HATFIELD BOROUGH PLANNING COMMISSION

March 25, 2024

**3. DIDDEN GREENHOUSES
PRELIMINARY LAND DEVELOPMENT
PLAN PRESENTATION**

RE: **Didden Greenhouses Land Development**
Review #2

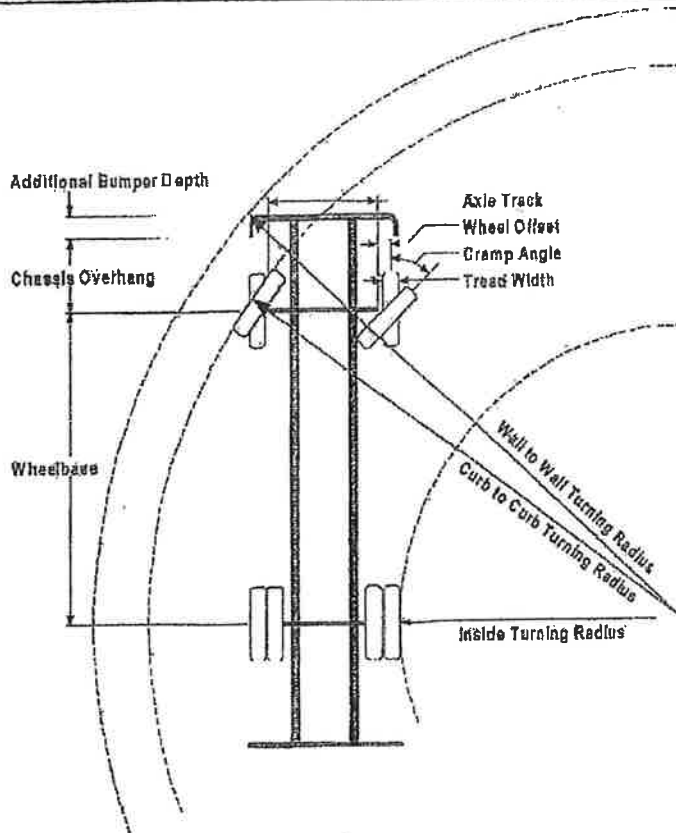
1. The access road turning plan provides modeling for a 32-foot trash truck and 68.5-foot interstate semi-trailer. Please provide a turning plan model for Ladder 17 (specifications attached).
2. Any bridges and/or elevated surfaces shall comply with section 503.2.6 of the 2018 IFC.
